B L A C K B O X

The purpose of the visit was the finalization of the Black Box design, with special emphasis on the control points and method.

Prosthetic Installation

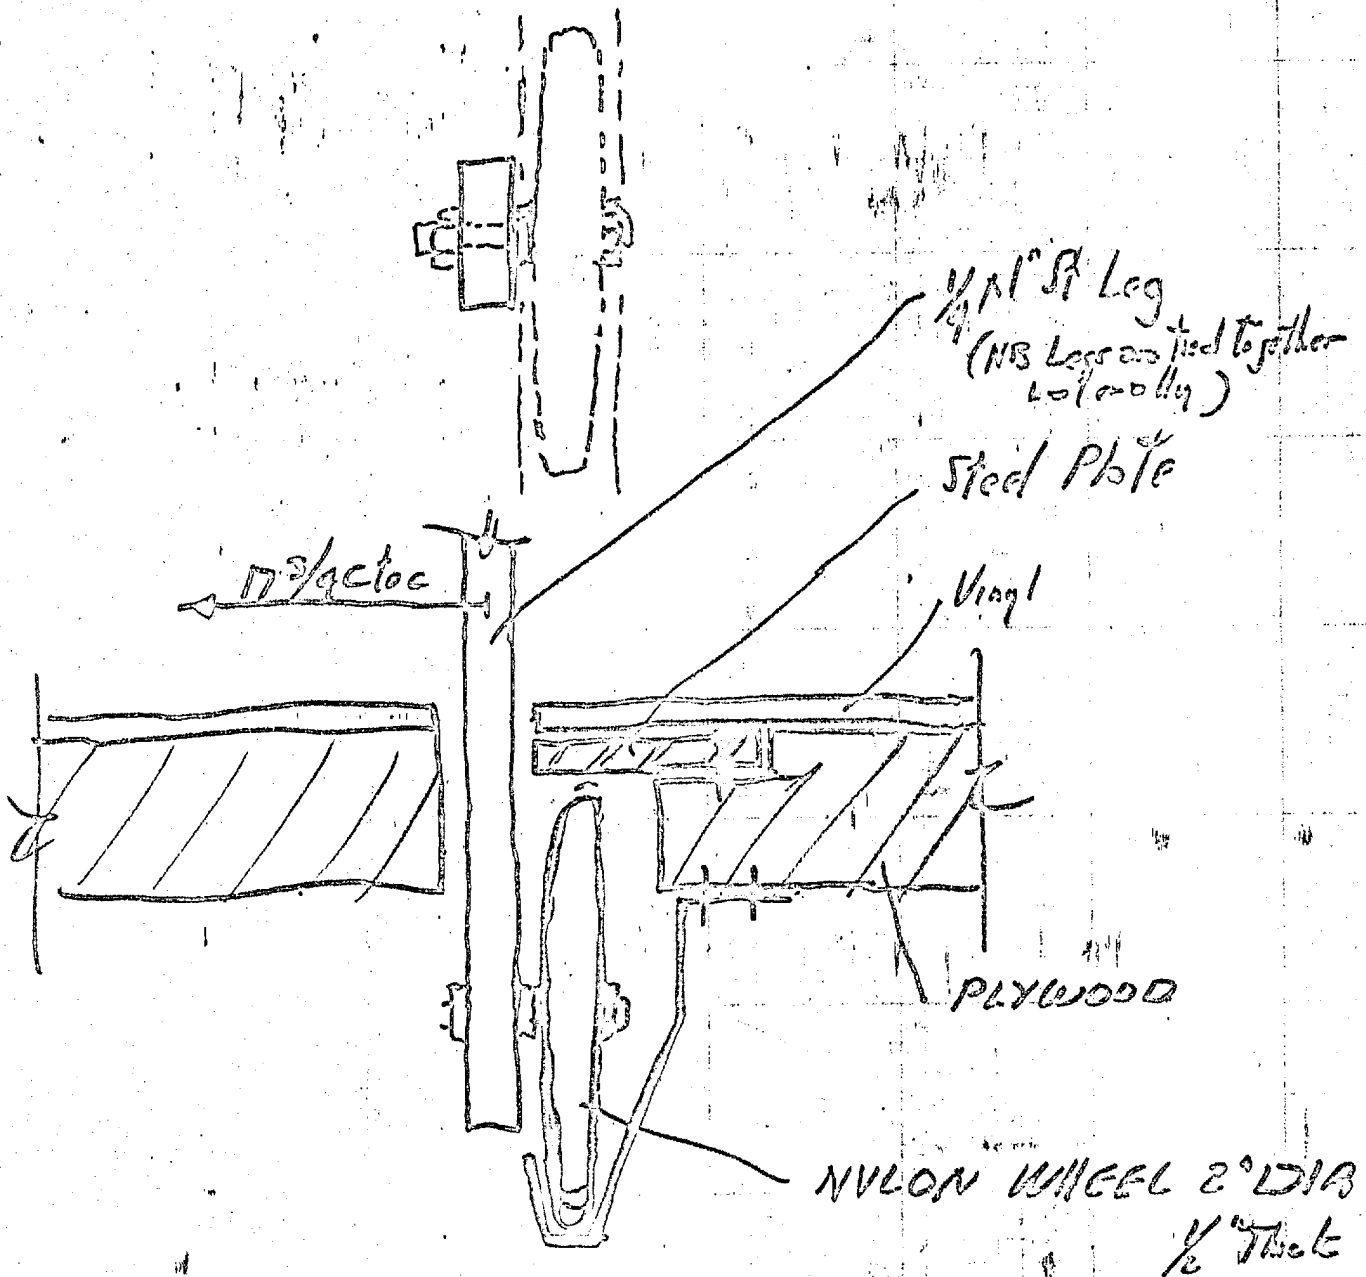
1. The first item to come up was the operators chair. The final one is in place and will require some drawing modifications. See attached sketch for dimensions and details. These should be incorporated into the working drawings before they go out for bid. It seems that overturn may be a problem because of a limited turn radius in the cockpit and no limit outside the cockpit.
